REFERENCE	BT_2010_FR20_03_UK
DATE	21th February 2010
SUBJECT	Parts available from Valencia collective tests
PART	Exhaust thermal shield, rear extinguisher support, crankshaft sensor additional loom

**FORMULA
RENAULT 2.0**

Exhaust thermal shield

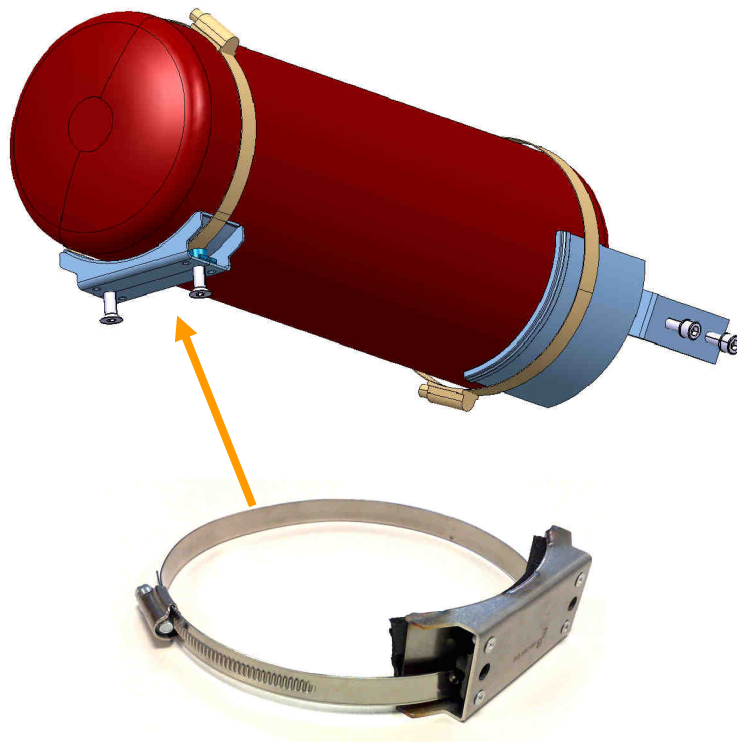
An exhaust thermal shield is now available from the Renault Sport spare parts Department. This thermal shield is mandatory and will be added to the Formula Renault 2.0 nomenclature as soon as possible.

The front support must be in contact with the shoulder of the intermediate line

On some cars, it could be needed to slightly bend the thermal shield to avoid any contact with the engine cover.

The thermal shield is delivered with its supports.
